SSHA Scarborough Warming
Centre - Phase 2

Basement
Plumbing Plan Below Slab
New

M1.3

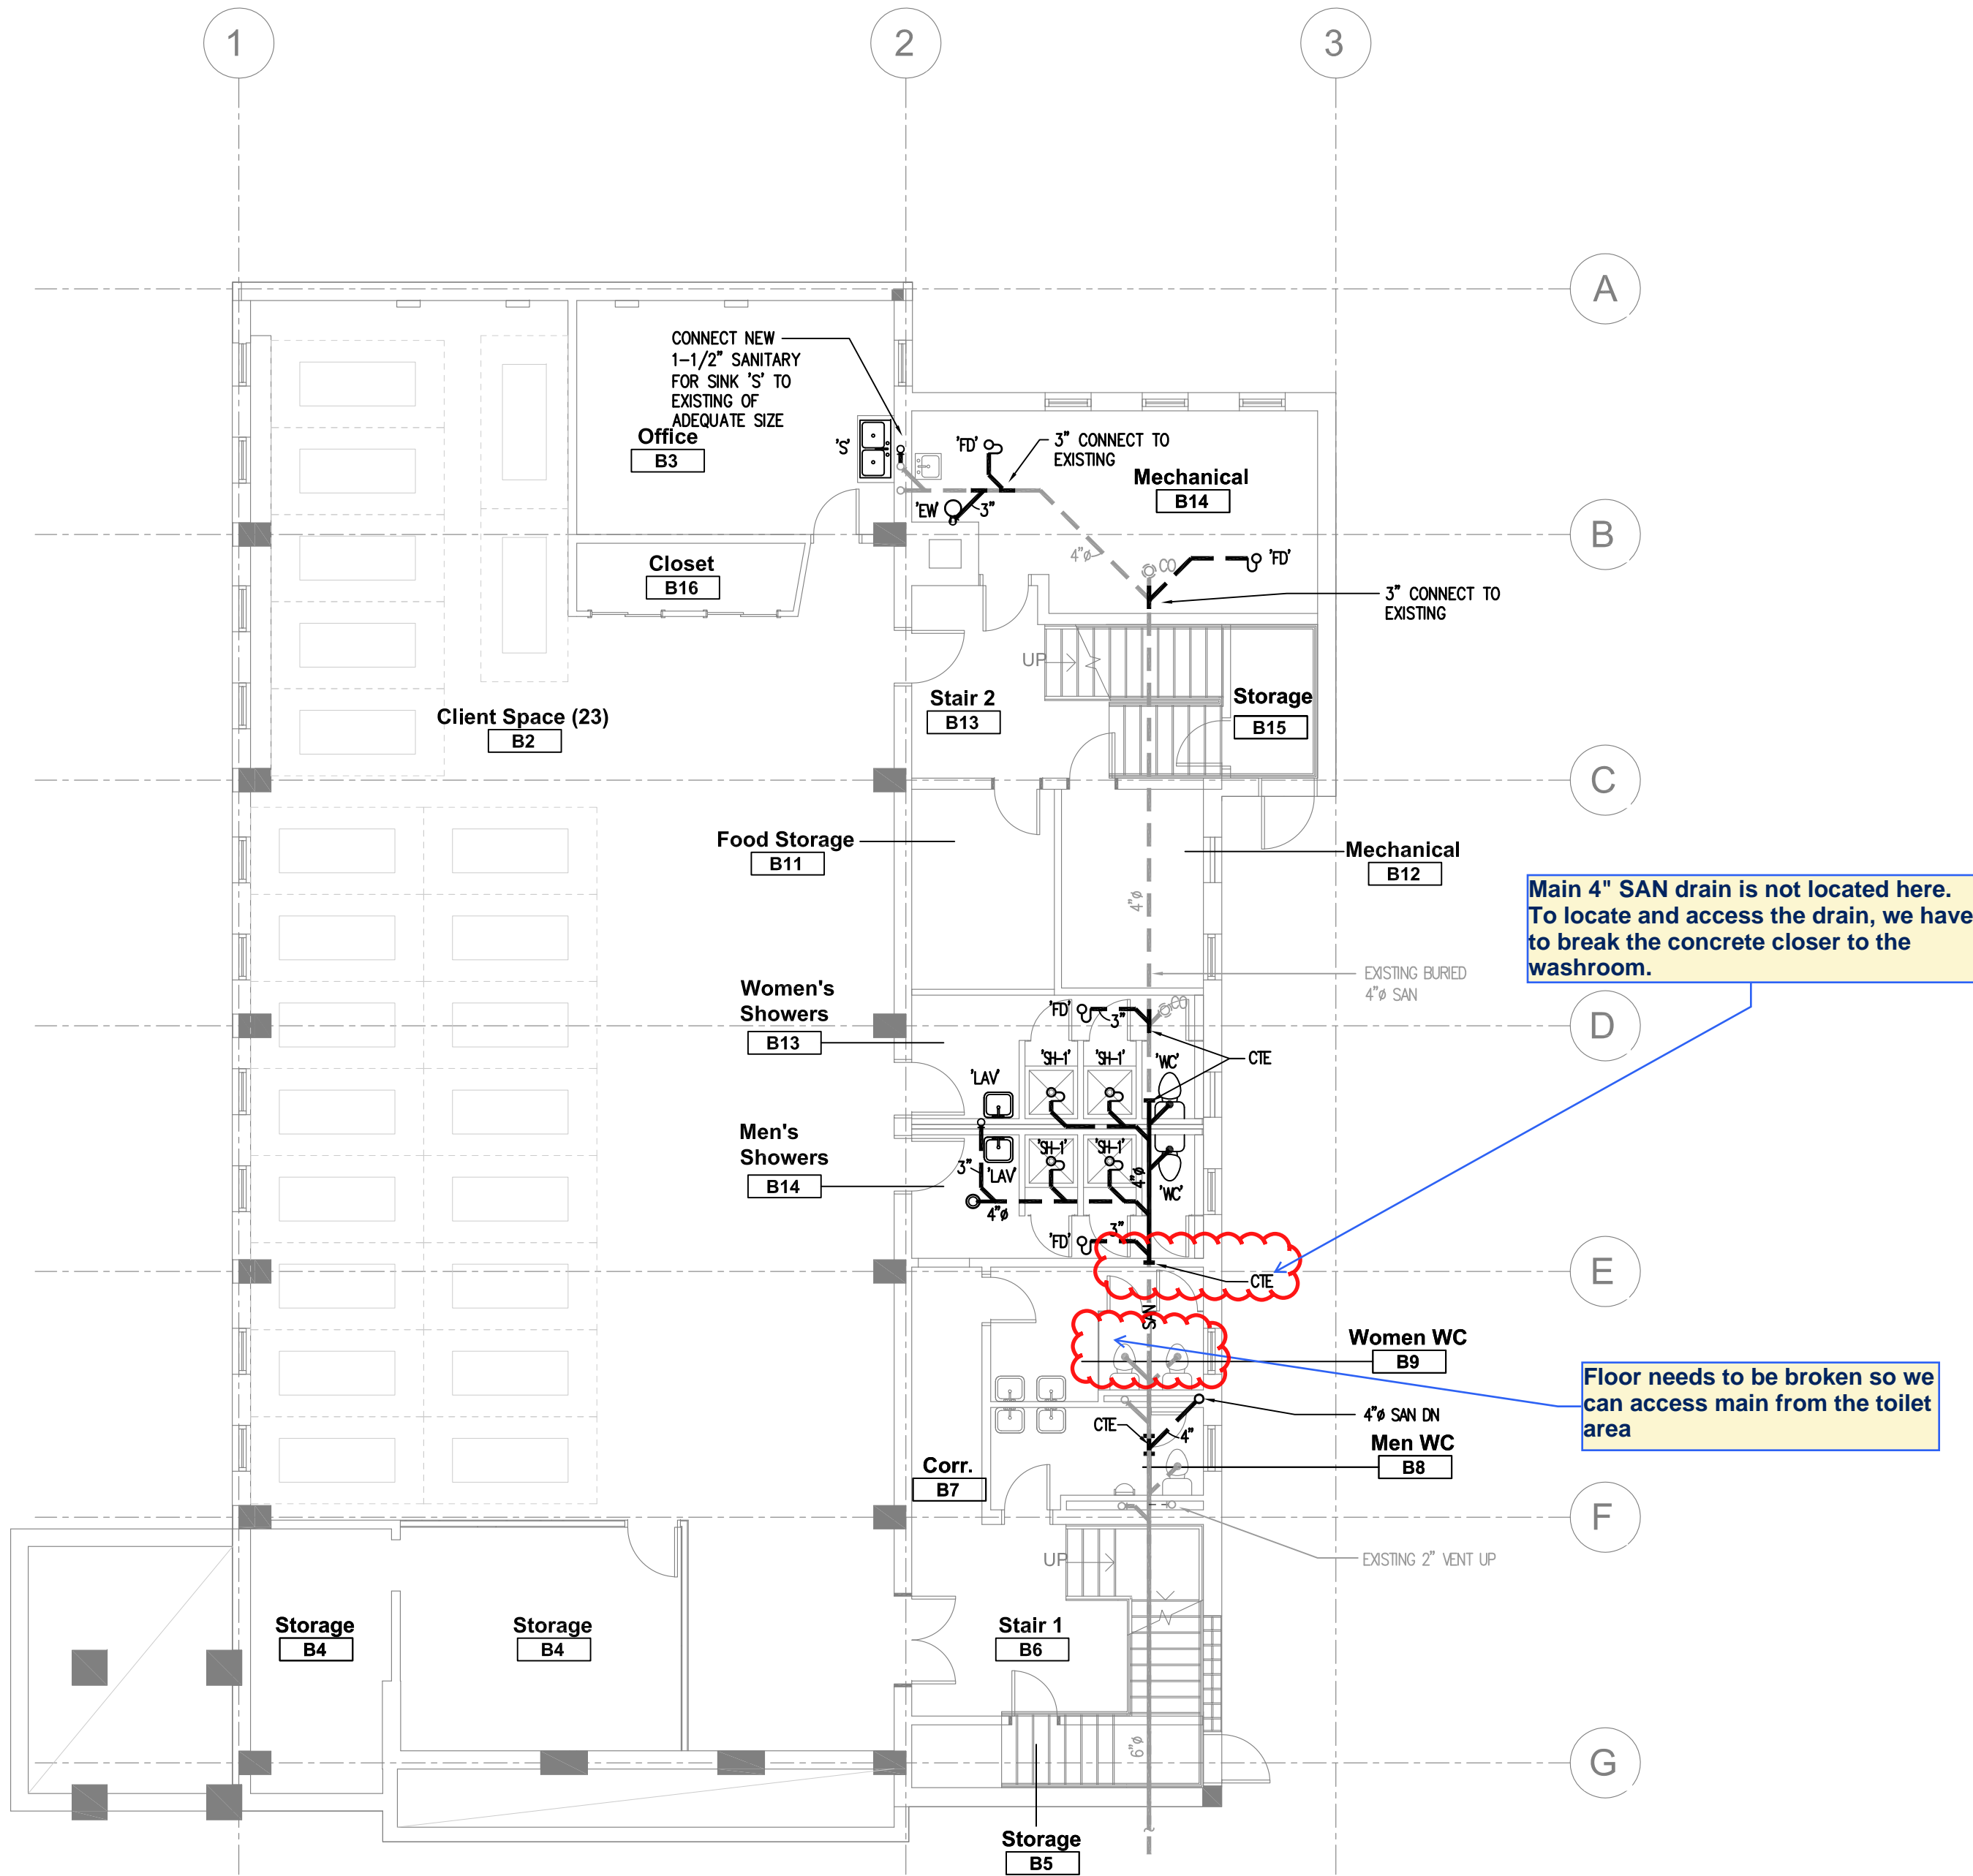
Main 4" SAN drain is not located here. To locate and access the drain, we have to break the concrete closer to the washroom.

Floor needs to be broken so we can access main from the toilet area

Existing 2"
kitchen drain
that
continues
only 2" thru
wall into
washroom

Area in
washroom
that needs to
be demo'd
